## **Economic Commission for Europe**

**eTIR conceptual, functional and technical documentation**

**Version 4.3**

## **Minor corrections included in revision 2**

Figure 11  
Record declaration data activity diagram

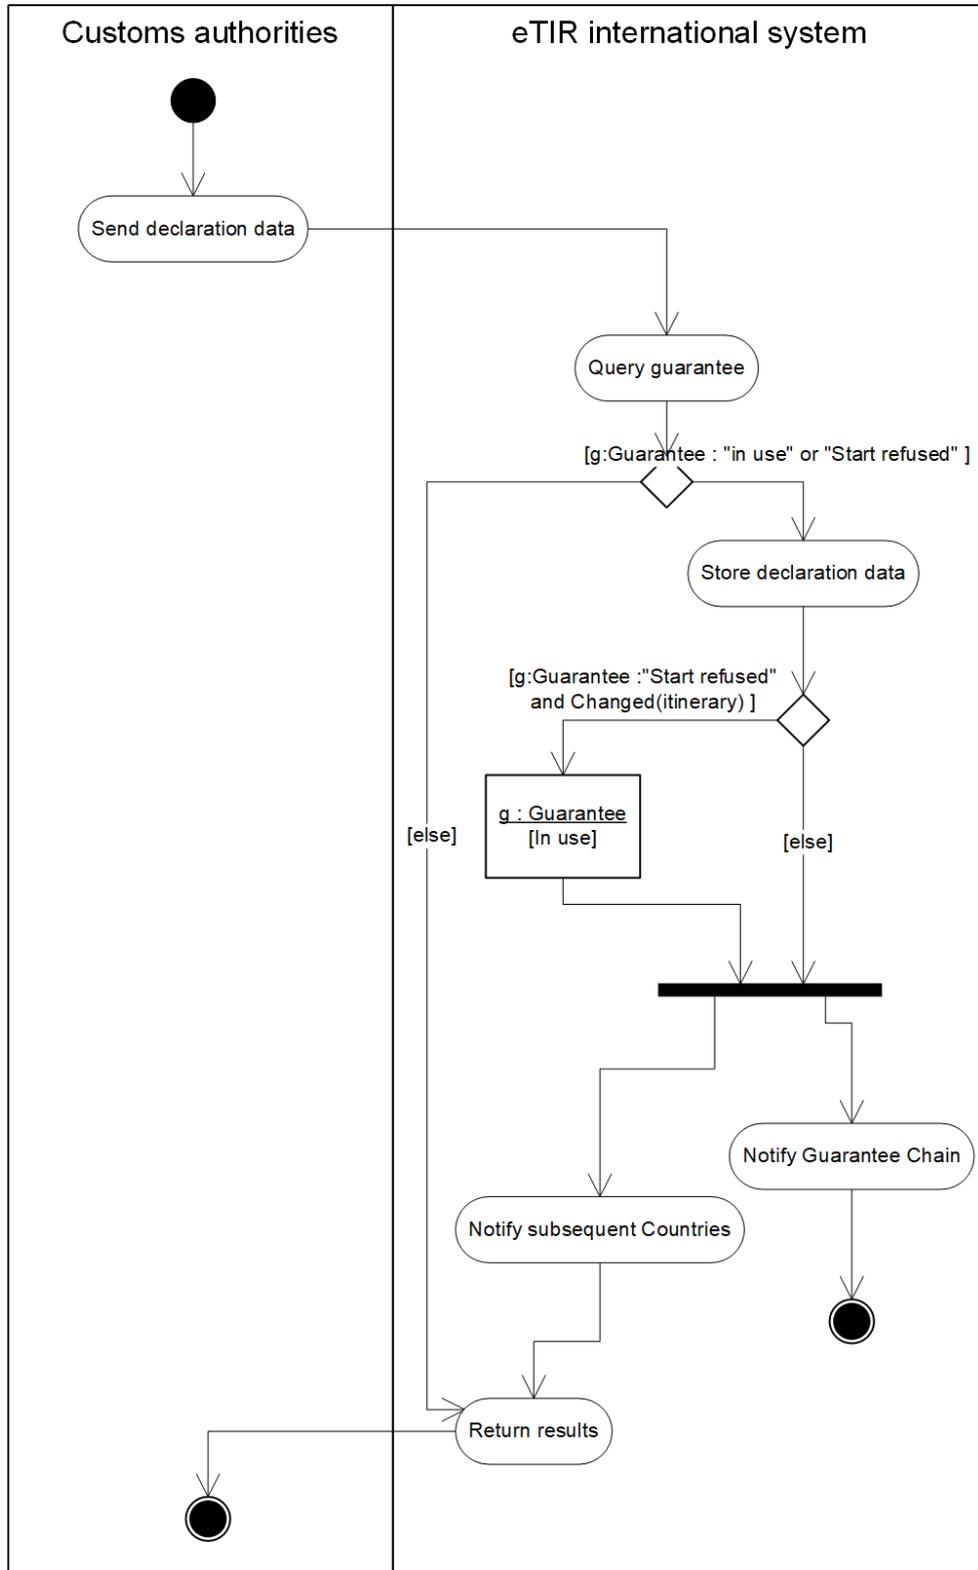
7. Various changes had to be introduced in Table 7, 8 and 9 as well as in Figures 11, 12 and 13 because of the following reasons:

- Annex 11, Article 10, paragraph 1 states clearly that the eTIR procedure cannot be started in fallback mode
- Seals information is transmitted by means of the I9 and I11 messages
- The accompanying document contains information on seals and is reprinted when they are changes, e.g. after customs controls (see Functional specifications Chapter IV.1.1.1)
